Memorandum

Project Location: Smalls Sliders
210 SW Oldham Parkway
Review: Plan Review
Lee's Summit, MO 64081

Re: Building Permit Plan Review; PRCOM20254584

MODELS A80, A110

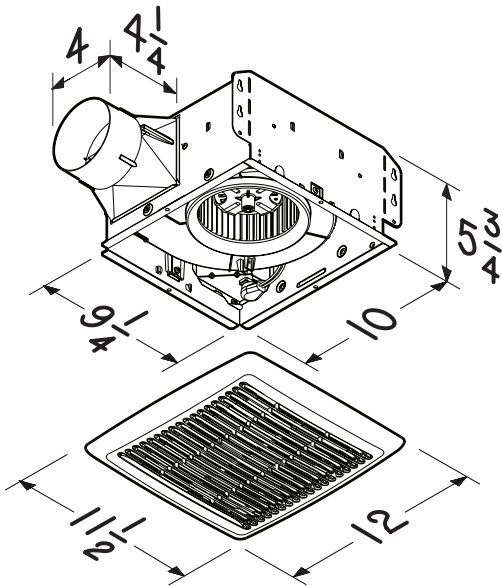
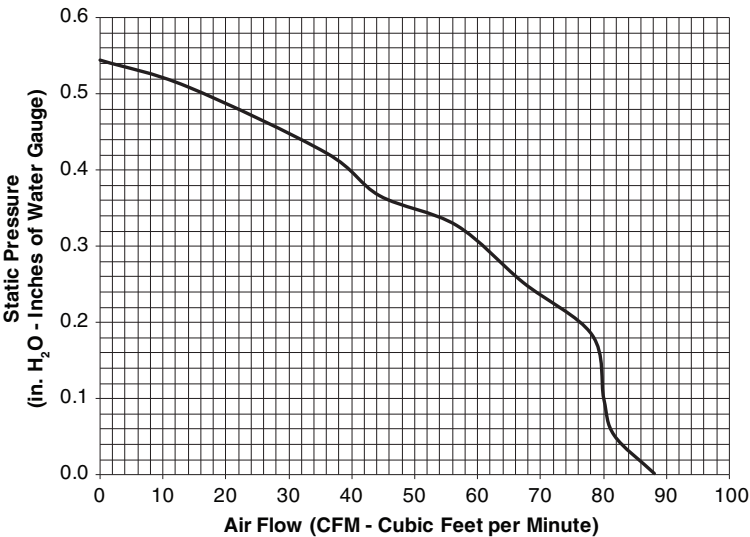
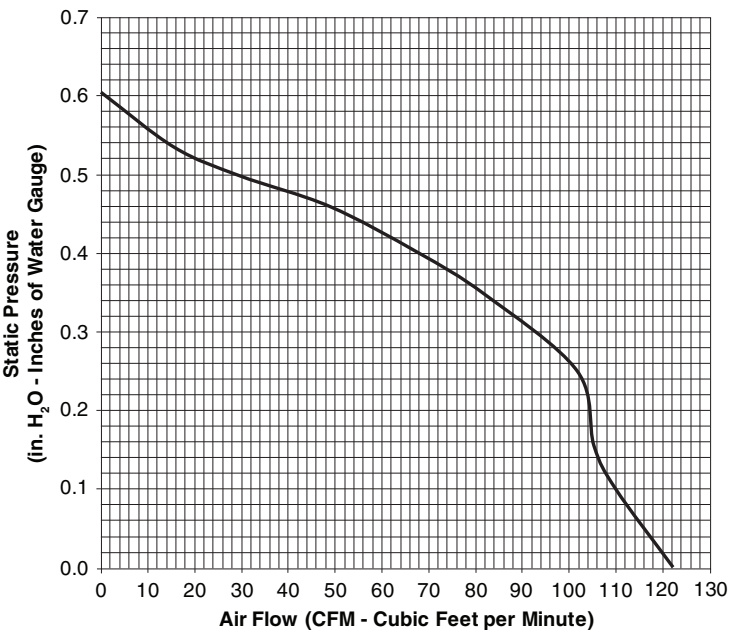
7. *2018 IMC 403.2 Outdoor air required. The minimum outdoor airflow rate shall be determined in accordance with Section 403.3. (see code for exception)*

Action required: Provide exhaust fan(s) at restrooms.

Response: by Daniel Matinez, Project Manager for Valient Modular LLC – Exhaust fans are provided in the restrooms. See sheets A2.1 and E1.1. Spec data sheet is provided following this letter.

EB45 Pressure Regulating Valve

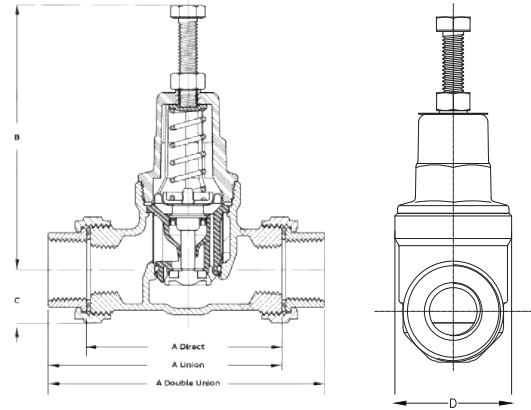
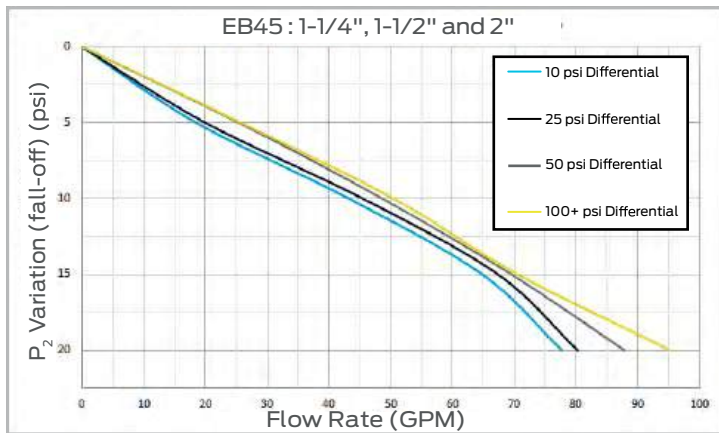
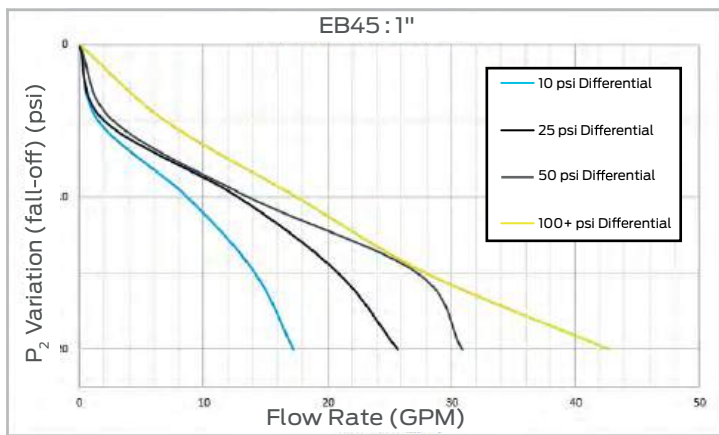
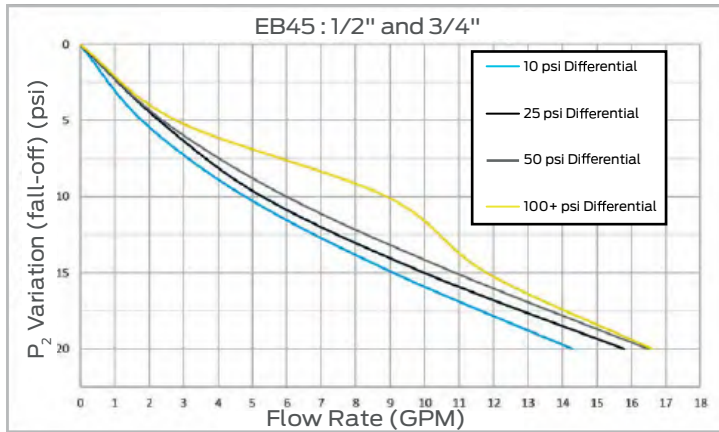
9. *2018 IPC 604.8 Water Pressure reducing valve or regulator. Where water pressure within a building exceeds 80 psi static, an approved water-pressure reducing valve conforming to ASSE 1003 or CSA B356 with strainer shall be installed to reduce the pressure in the building water distribution piping to not greater than 80 psi static.*

Action required: Provide pressure reducing valve at water entry. (Our Water Department requires PRV installation in all locations regardless of pressure)

Response: by Daniel Matinez, Project Manager for Valient Modular LLC – Added to sheets P3.1 and P6.1. Spec data sheet is provided following this letter.
